Fastrack **news**

official SCCA member notification

CLUB RACING BOARD MINUTES | December 2, 2025

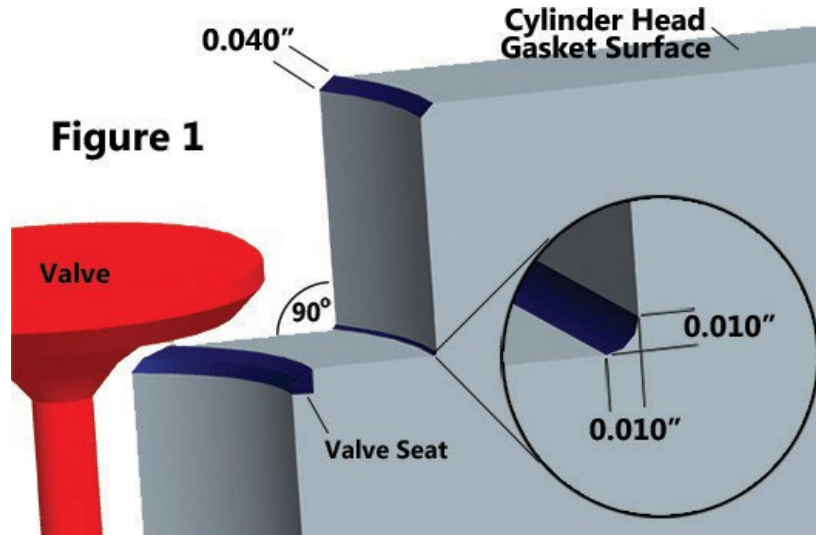
- There must be a sharp, non-modified and non-deburred edge where the valve relief cut first meets the chamber.
 - No part of this cut (except where it intersects the head gasket surface, which may be deburred up to .040") is to be blended by hand, machined, or chemically processed to create a smooth transition. See figure 1 below.
